Platt Ridge Drive Extended Drive, Mandatory Referral No. MR2014012

Completed: 03/27/14

Summary

Staff recommends that the Board disapprove this project with comments to MCDOT. We also recommend that the Board transmit comments to the County Council advising them as part of their CIP deliberations to cancel the project or, alternatively, to delay the project for several years (see Attachment 1).

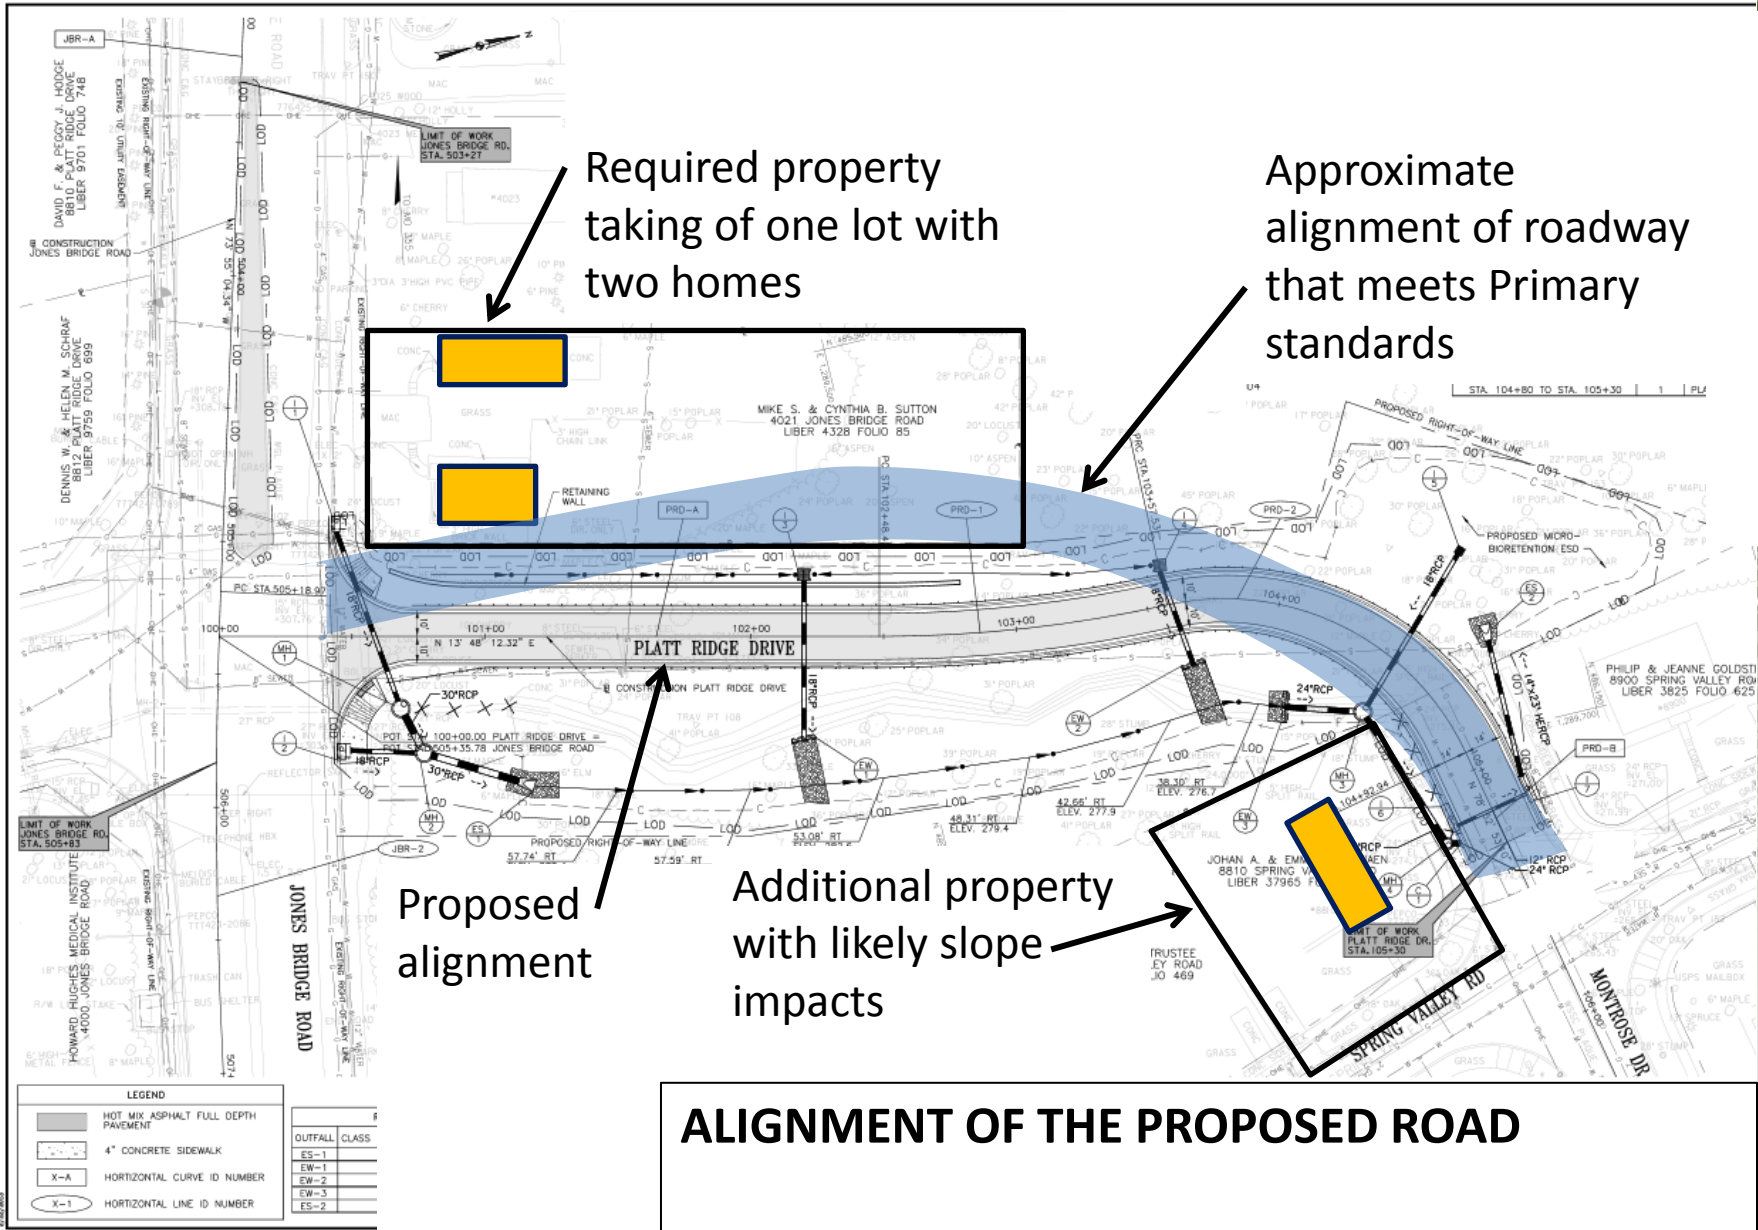
Required property taking of one lot with two homes

Potential Conversion of the Spring Valley Road Traffic Signal to a Half-Signal

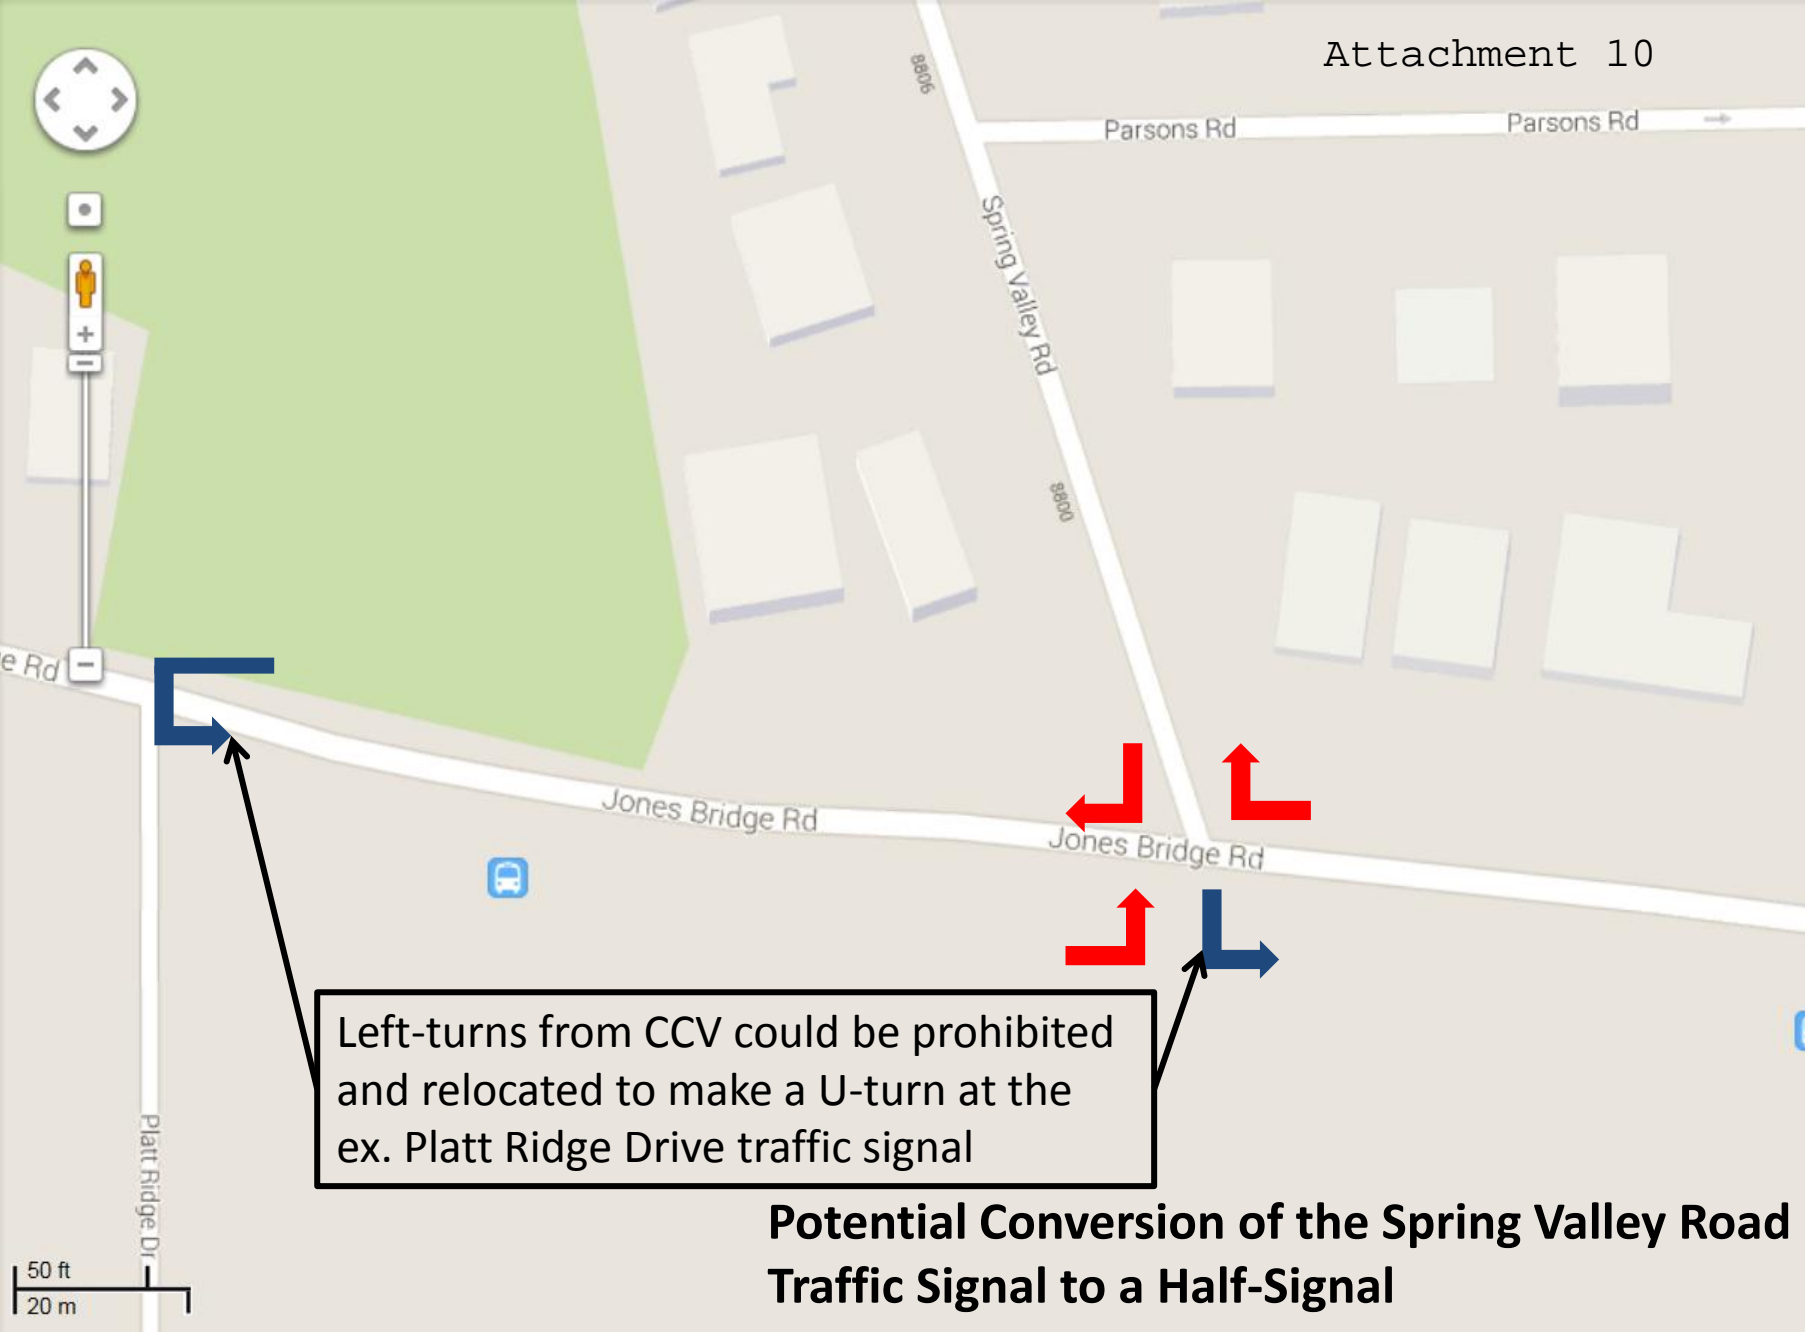
Left-turns from CCV could be prohibited and relocated to make a U-turn at the ex. Platt Ridge Drive traffic signal
